Duquesne Light Company
(Beaver Valley Power Station, Unit No. 1)

APPLICATION FOR AMENDMENT
INSERVICE INSPECTION REQUIREMENTS

Requests for Relief from Hydrostatic
Inservice Inspection Requirements

Attachment D.2

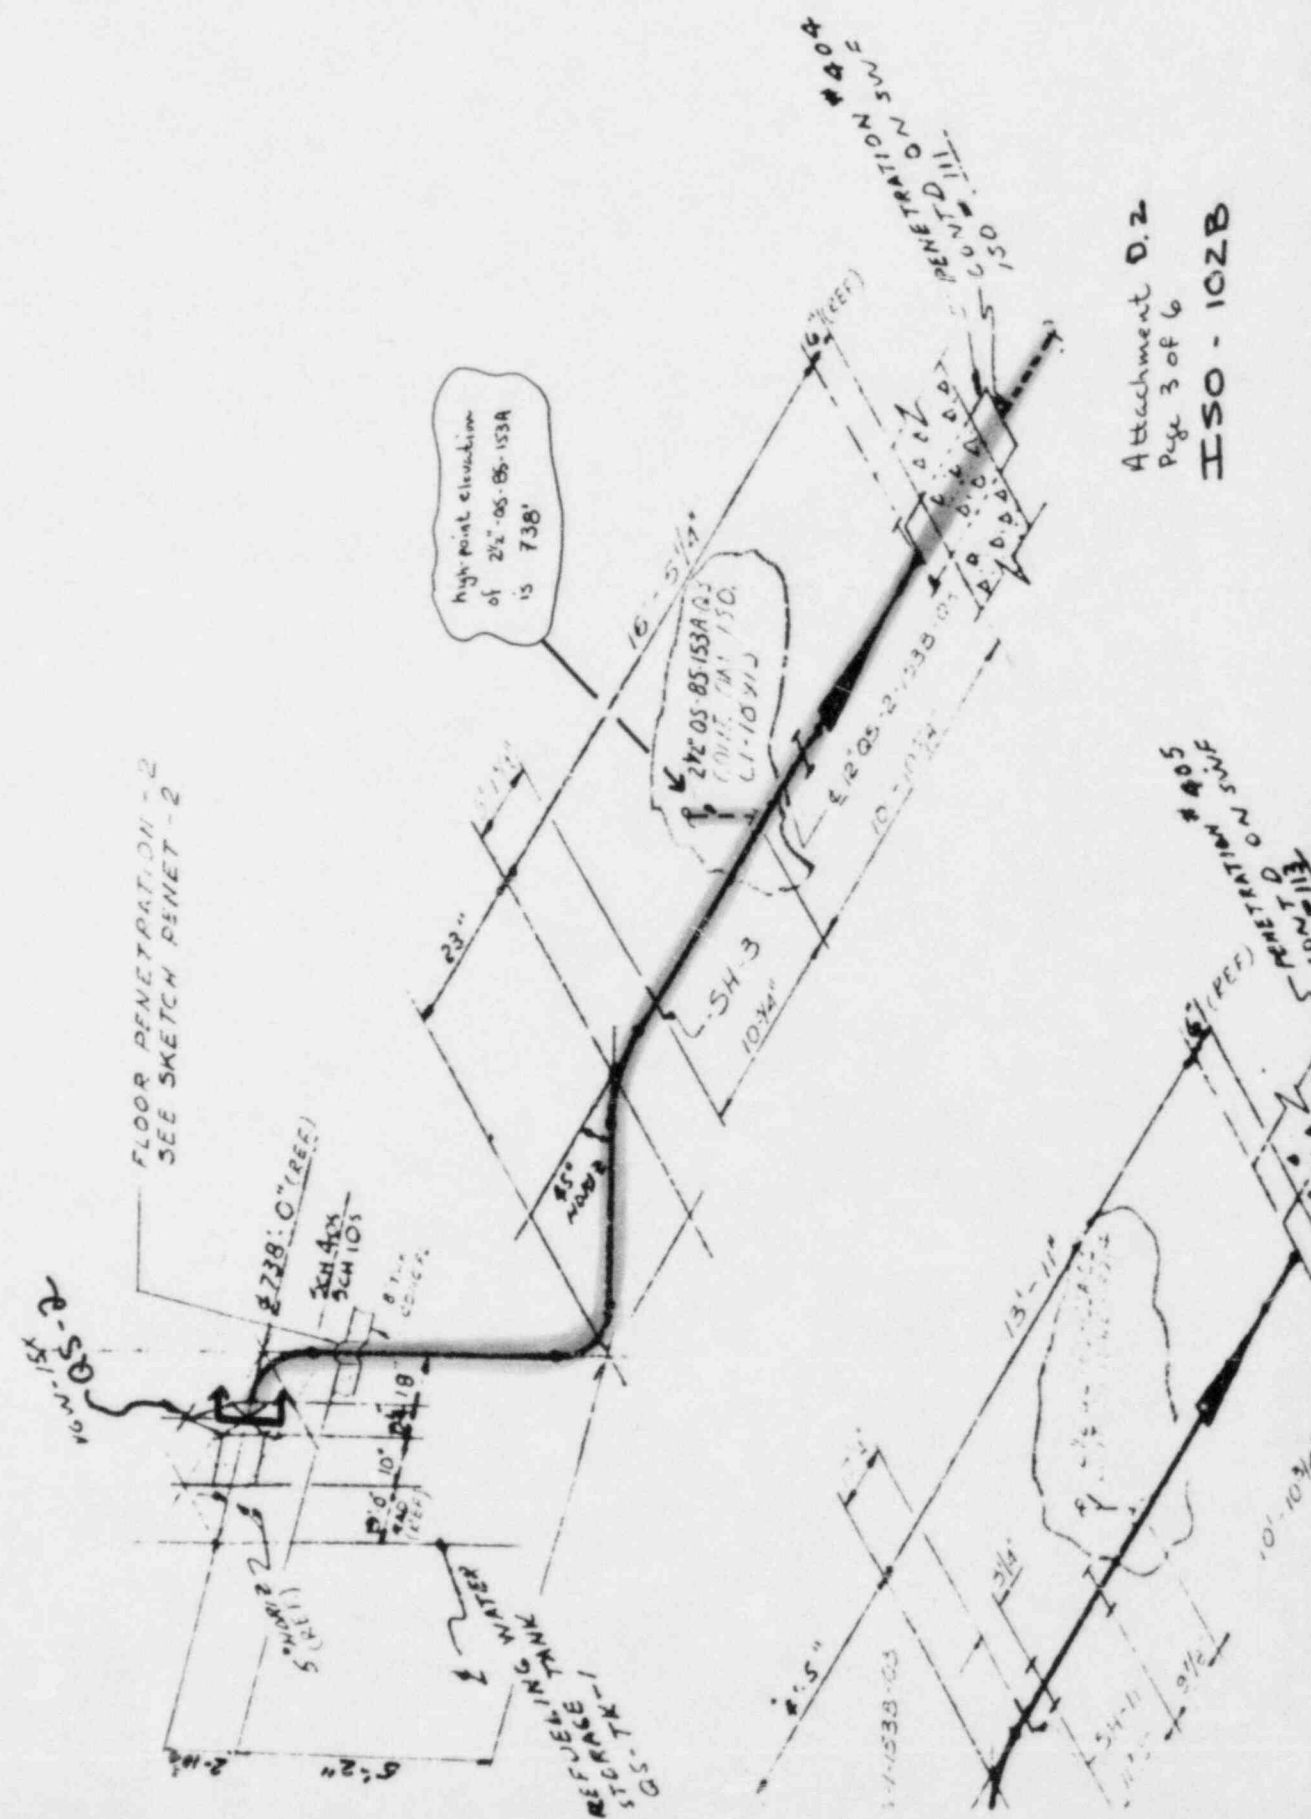
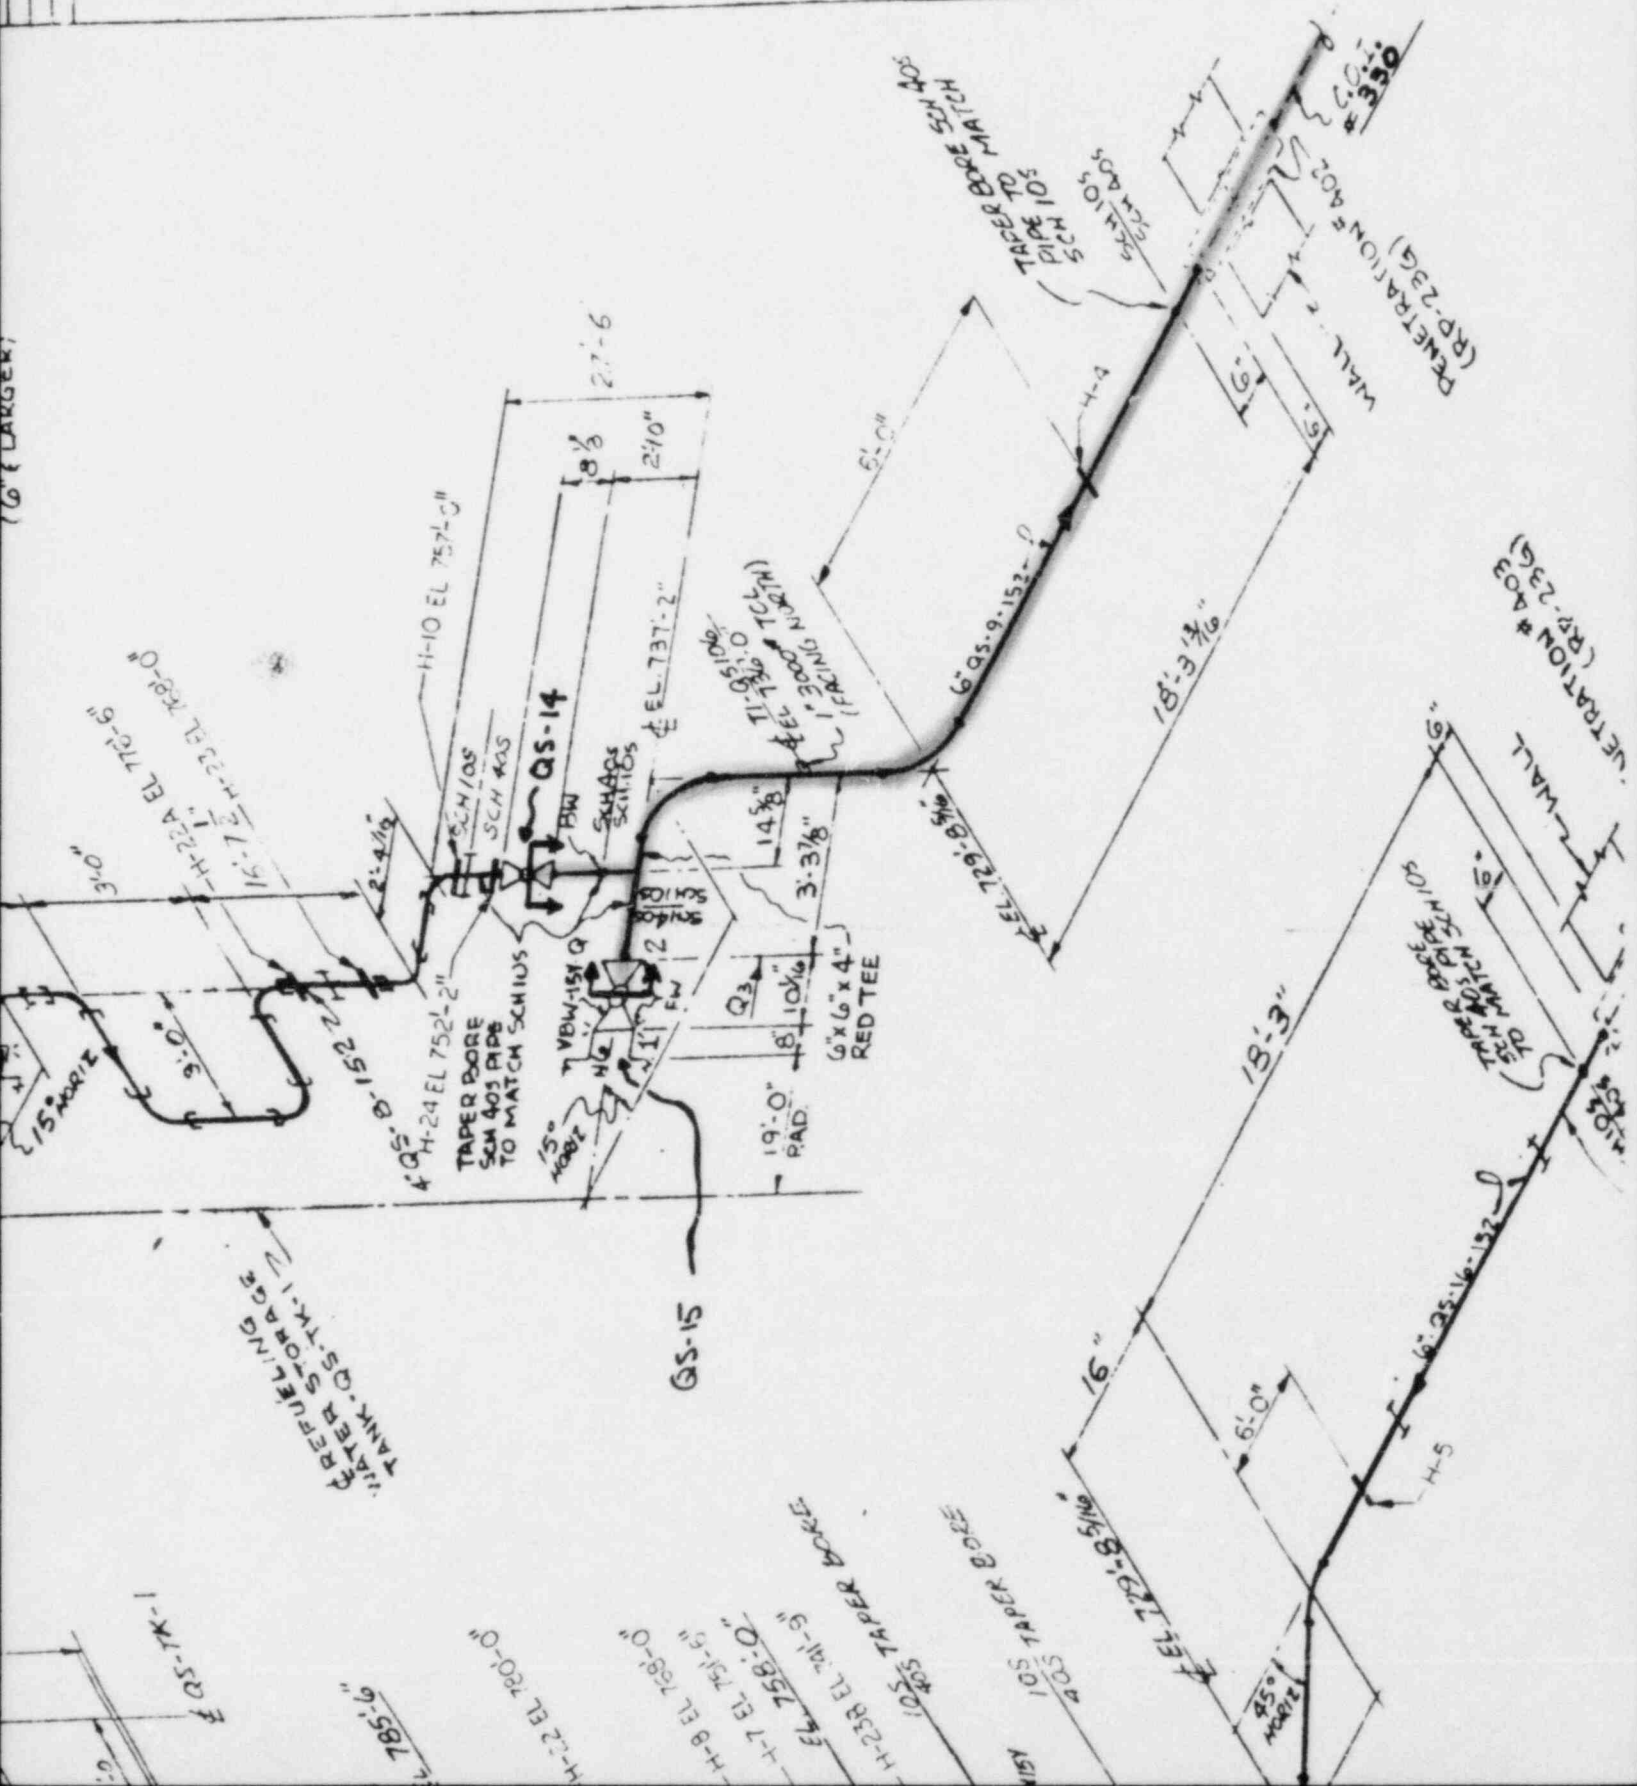
The following sections of Class 2 Quench Spray System piping are affected (see Attachment D.1 and D.2 drawings):

The design pressure of the affected piping is 20 psig. In accordance with IWC-5222(a) and IWD-5222(a) the hydrostatic test pressure would be 22 psig. Using the static head developed by the maximum level (elev. 787'6") in the Refueling Water Storage Tank (RWST) as the hydrostatic test pressure would apply the code required test pressure (at least 1.1 Pd) to the majority of the test boundary. The high point of the test boundary (elev 740'7") would be at a pressure of 20.3 psig, still above the design pressure rating of the system but below the code required test pressure of 22 psig.

The portion of the Quench Spray System noted above will be examined during hydrostatic testing using the static head of the maximum level of the RWST as the hydrostatic test pressure.
